Product Change Notification

Change Notification #: 115327 - 00
Change Title: Intel® Compute Module HNS2600KPFR
PCN 115327-00,
Product Material, Product Design,
Replacement of components listed under RoHS
exemption 7c-I, Change Node Tray Assembly

Date of Publication: March 07, 2017

Figure 1. Post-Change Tray Assembly

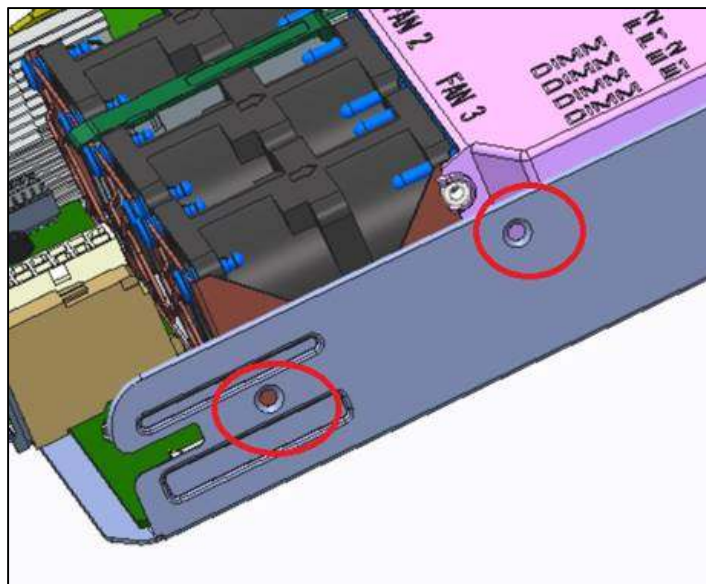
1. Intel is replacing components containing substances listed under EU RoHS exemption 7c-I with exemption-free. All new components are identical in form factor and function to the replaced ones.
2. Intel is implementing the following change on the node tray assembly to support specific form factor NVDIMM supercaps by adding support holes to the tray. Please refer to Figure 1 for illustration.

Figure 2. Post-Change IOM Blank Filler

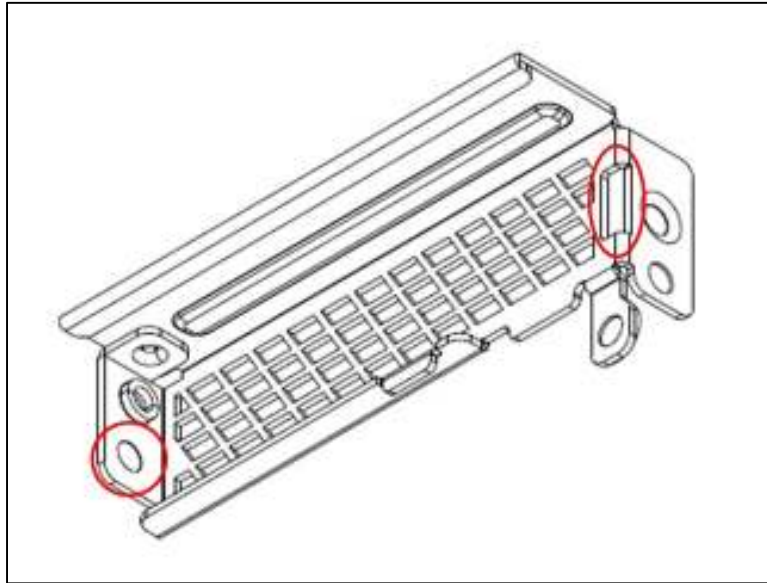
3. Intel is implementing the following change on the node IOM blank filler to support the M.2 carrier by adding a support hole and a piece holder. Please refer to Figure 2 for illustration.
